POWERTECH (USA) INC.

Re: Powertech (USA) Inc. Comments on Dewey-Burdock Project Draft Class III Area Permit

This letter and attachments represent Powertech (USA) Inc.'s (Powertech's) written comments on the Draft Class III Area Permit for the Dewey-Burdock Project issued for public comment in March 2017. The written comments pertain to the draft permit, Draft Class III Area Permit Fact Sheet, Draft Aquifer Exemption Record of Decision and other supporting documents, including the Draft Cumulative Effects Analysis and Draft Environmental Justice Analysis. Following are general comments followed by specific technical comments (Tables 1 through 5) and additional comments included with proposed alternate solutions for several draft permit conditions (Attachments A-1 through A-10). References are provided as PDF files in Attachment B.

Figure A3-1. Dewey Wellfield 1 Potential Post-Restoration Groundwater Monitoring Wells.

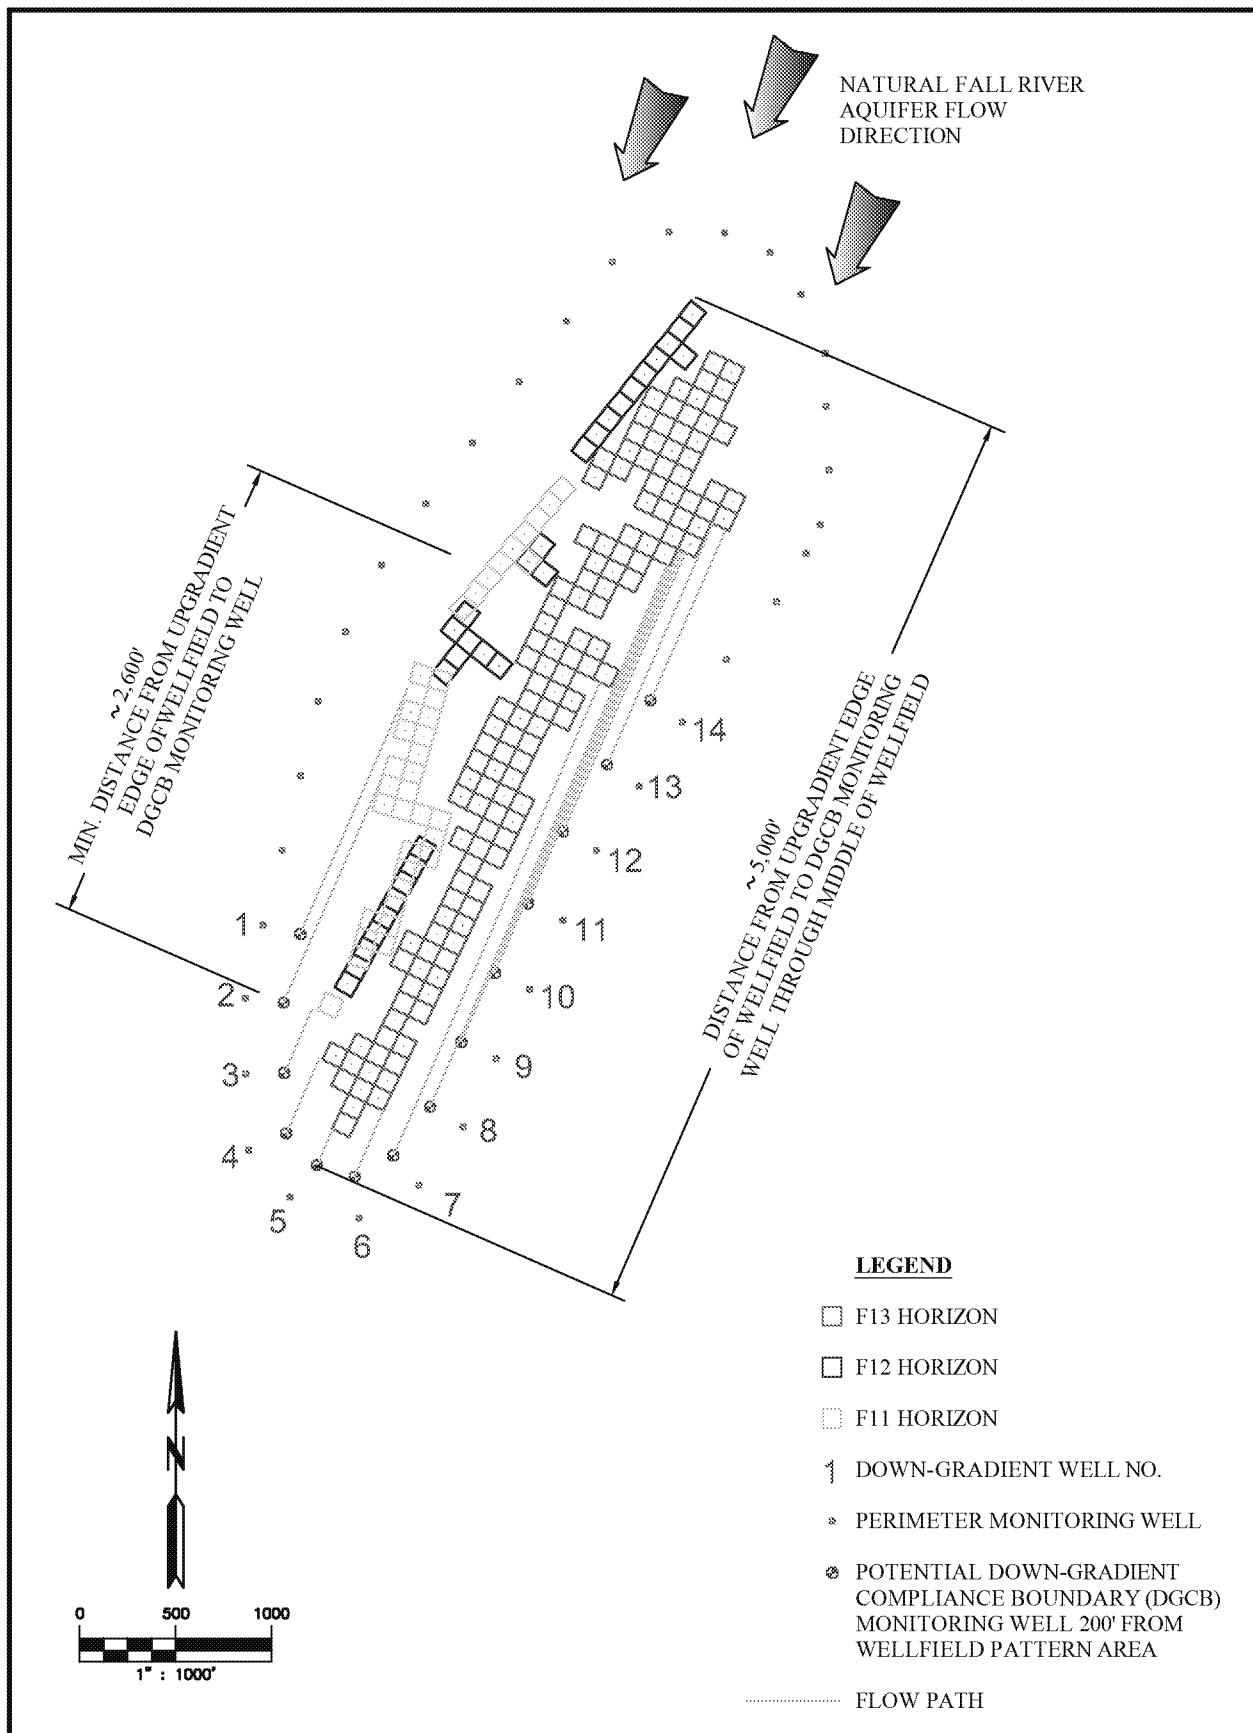
Figure A3-1 shows the approximate configuration of Dewey Wellfield 1, as depicted in Plate 7.1 of the Class III permit application, along with the natural groundwater flow direction from Figure 5.2 in the Class III permit application. This figure shows that the natural groundwater

gradient closely follows the longitudinal wellfield axis, much more so than what is depicted in Figure B4 in the Draft Class III Area Permit. The result is that the distance along the natural groundwater flow path between the wellfield and potential DGCB monitoring wells is much farther than the offset distance of the DGCB wells from the wellfield. This is illustrated in Table A3-1, which compares the distance along the natural groundwater flow path from the down-gradient edge of the wellfield to potential DGCB monitoring wells placed either 200 or 400 feet from the wellfield. The distance of groundwater travel ranges from 200 to 3,078 feet for wells placed 200 feet from the pattern area and 400 to 3,570 feet for wells placed 400 feet from the pattern area. Based on the average Fall River groundwater flow velocity of 6.1 feet per year, from Appendix 6.1-A (numerical groundwater flow model) of the approved NRC license application (Exhibit 018 at p. 6.1-A-11), it would take 33 to 505 years for groundwater to reach DGCB monitoring wells placed 200 feet from the wellfield or 66 to 585 years to reach wells placed 400 feet from the wellfield. Since the draft permit would require verification that the tracer reaches each DGCB monitoring well, it would be necessary to wait at least 500 years for groundwater to reach the most distant wells under natural groundwater flow conditions.

Given that Dewey Wellfield 1 would be about 4,700 feet long, the travel time from the upgradient edge of the wellfield to potential DGCB monitoring wells would be hundreds of years for any well. Figure A3-1 shows that the minimum distance would occur for potential DGCB monitoring well location 2, southwest of the wellfield. Even this minimum distance is more than 2,600 feet, corresponding to a travel time of 400 to 500 years. If it were necessary to inject a
